NLT Product Change Notice
PCN Tracking Number: NLT-PP-5065

15.0" XGA NLB150XG01L-01

2. Description of change:

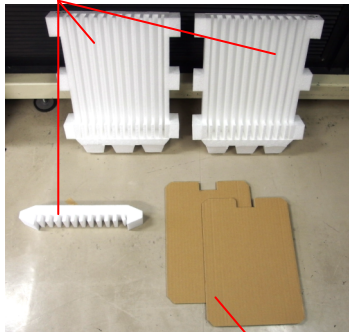
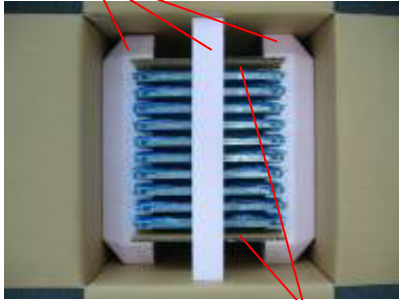
We change the packing of LCD module.

According to this change, some components will be changed as follows.

Item	Description of the change
Outer box	Outer box will be deleted.
Inner pad Partition board	The inner pad and the partition board in the product packing box will be changed. Please refer to "4. Inner pad and partition board".
Packing box	Its size is changed. Please refer to "5.Packing box"
